### COLLIN COUNTY, TEXAS

ADDENDUM No. Two (2)

### <u>CONSTRUCTION, NEW OFFICE BUILDING FOR PRECINCT 2</u> <u>JUSTICE OF THE PEACE & CONSTABLE</u>

Architect's Addendum Number Two

0 10 20

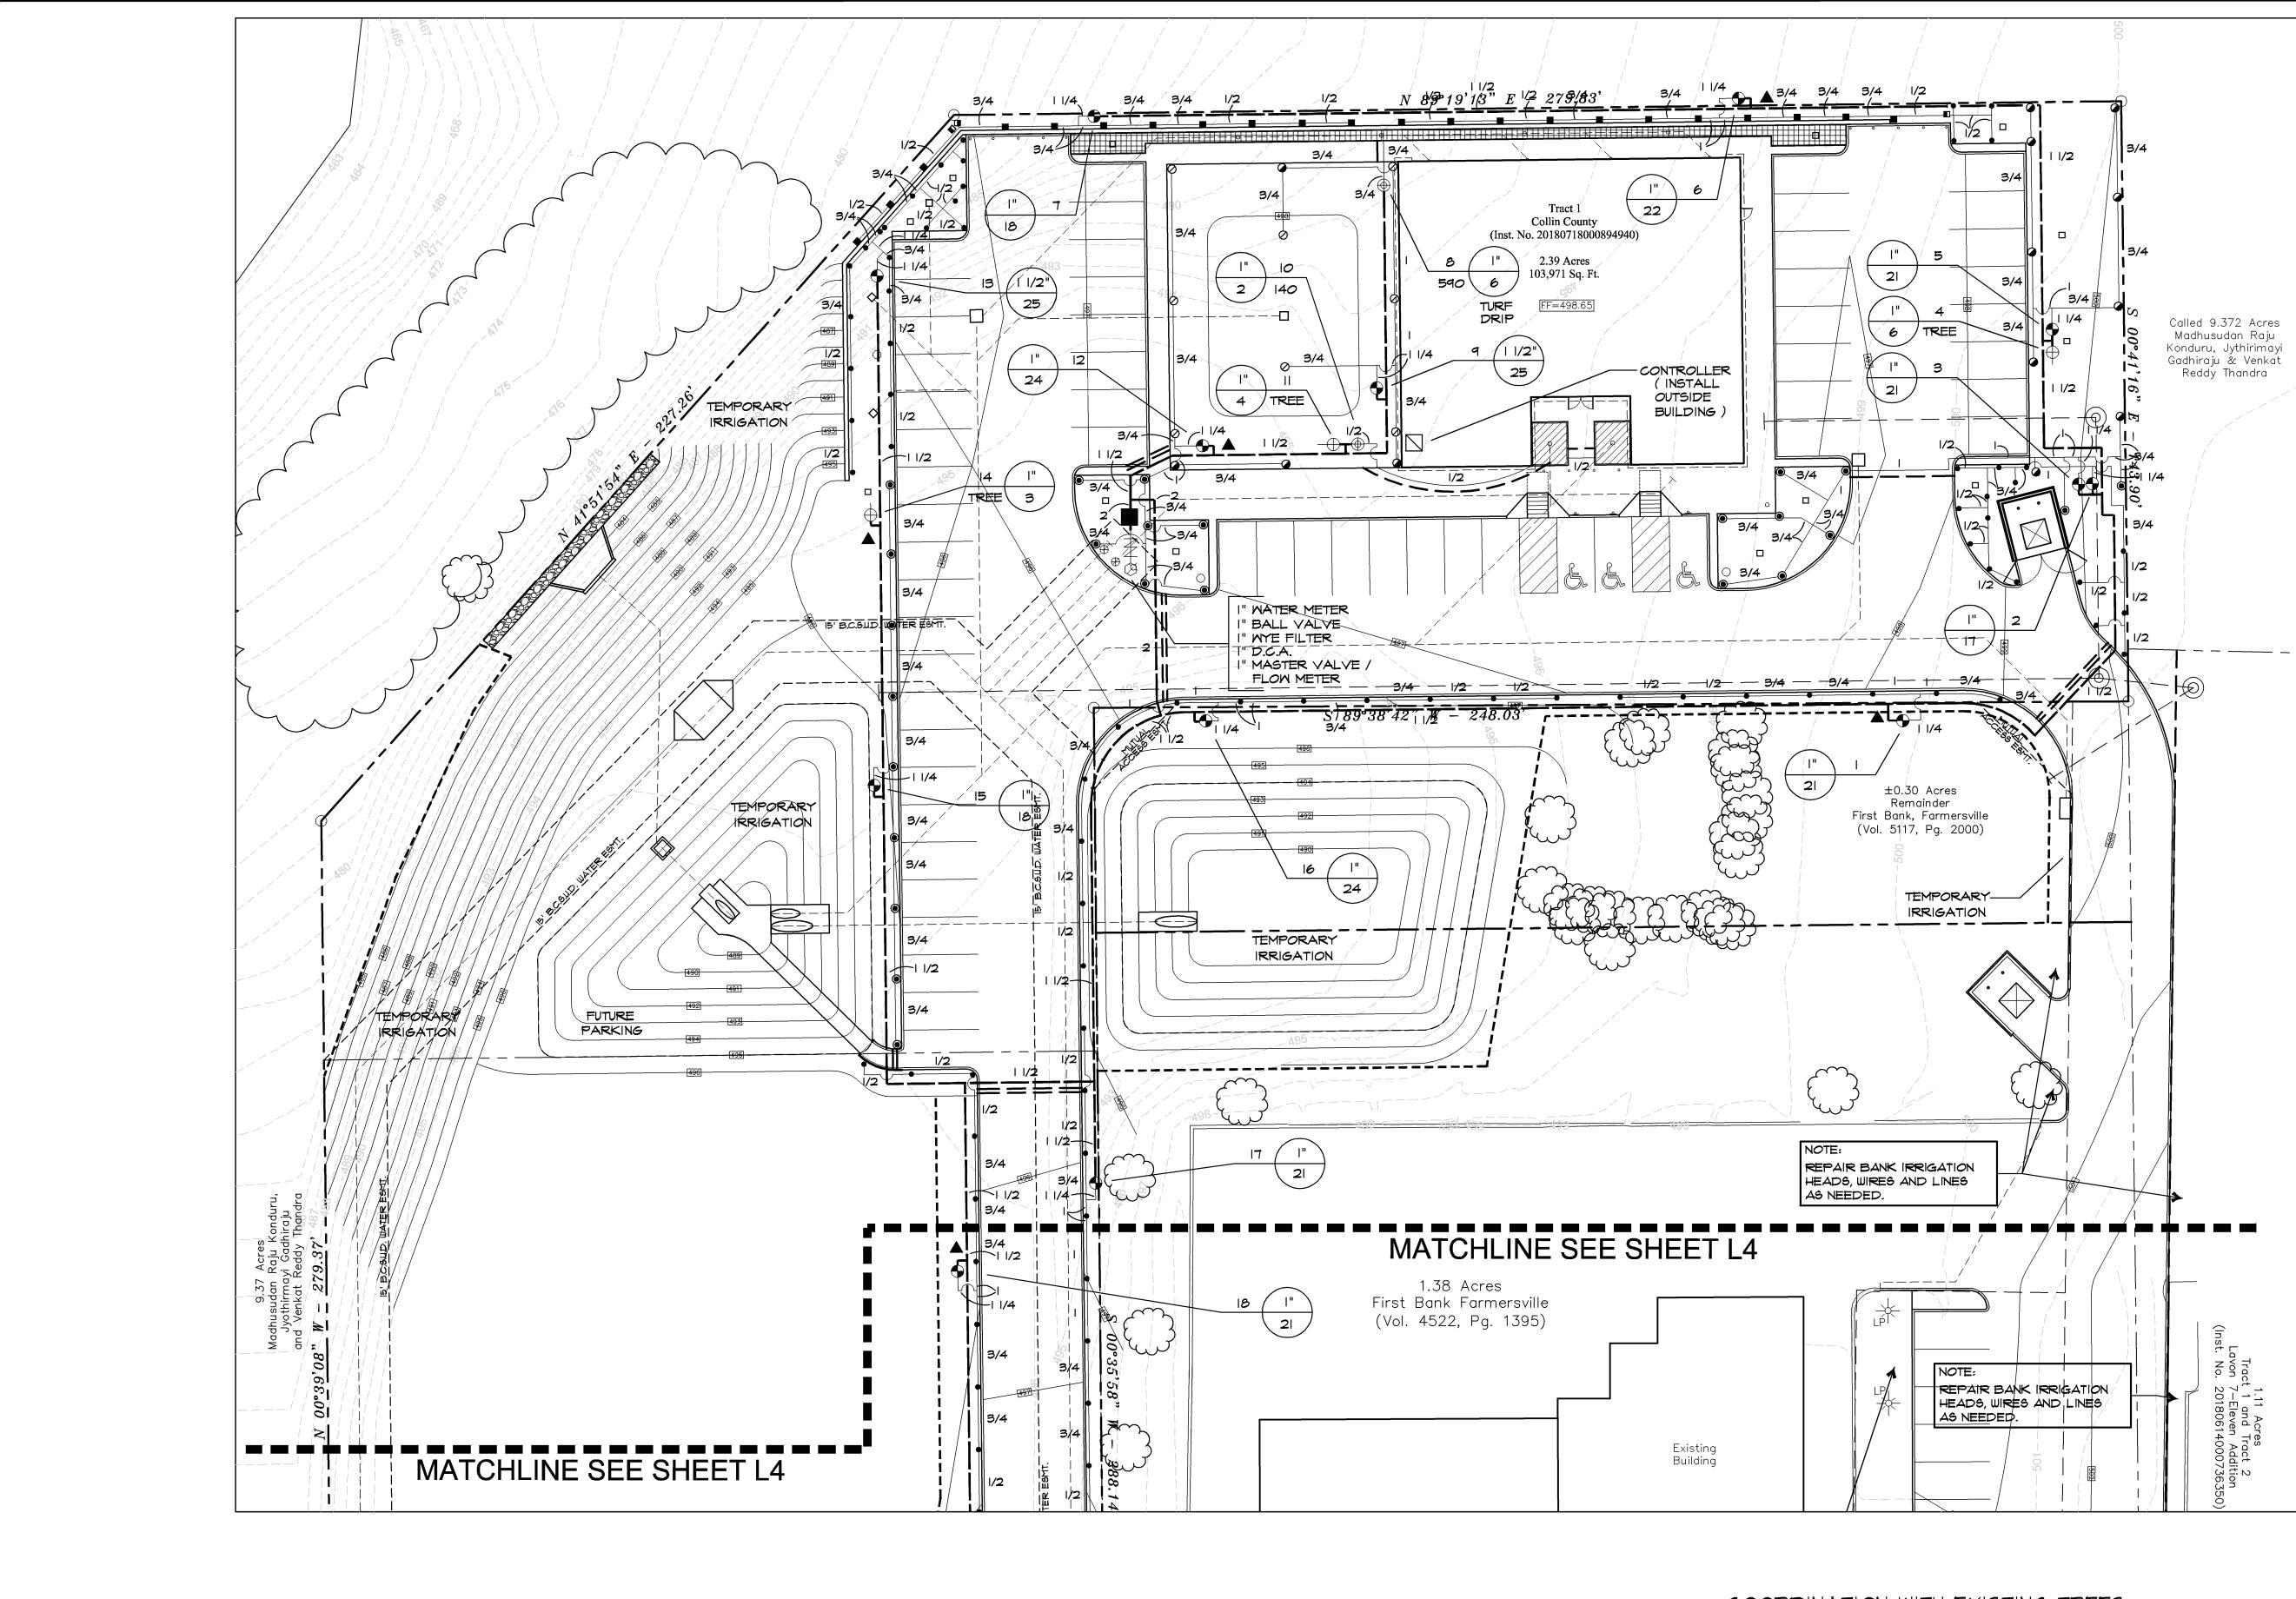
- Item 6: Corrections: Refer to attached Landscape & Irrigation Drawings L1, L2, L4 & L5: Additional notes have been added regarding sod and irrigation system repairs on the bank property, particular east of the bank where LS islands around the site light poles and parking are being modified and in the SW corner of the property where the bank's approach is being removed and the drive extended across the property line to the new approach.
